SERVICE BULLETIN

M-980

REPLACEMENT SPRINGER ROCKER PIVOT STUDS

Figure 1. Old & New Pivot Stud Head Comparison

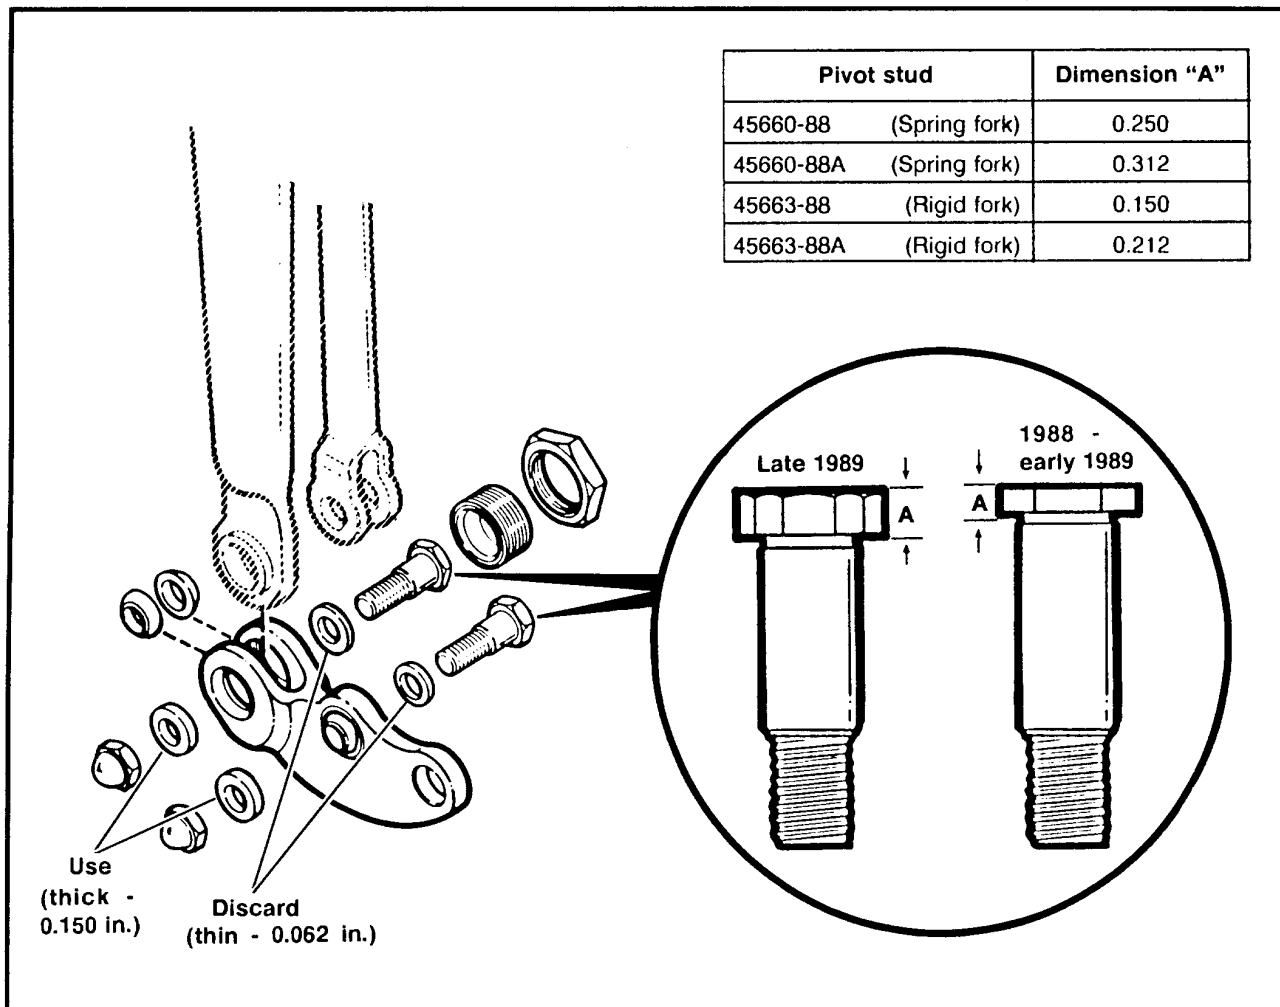
See Figure 1. Rocker pivot studs, 45660-88 & 45663-88, have been redesigned and are being manufactured with a thicker head.

The new pivot stud part numbers are 45660-88A; rigid fork pivot stud and 45663-88A; spring fork pivot stud.

The new stud heads eliminate the need for the thin spacers, 45661-88. The thin spacers should not be used under the the new pivot studs' heads. Continue to use the thick spacer, 45662-88 under the pivot studs' acorn nuts.

Do not use the thin spacers under the head of the 45660-88A & 45663-88A pivot studs. If you use the spacers under the heads of the new studs, thread engagement and head clearances will be incorrect. Continue to use the thick spacers 45662-88 under the pivot studs' acorn nuts.

Continue to use 45–50 ft-lbs torque when tightening the acorn nuts.
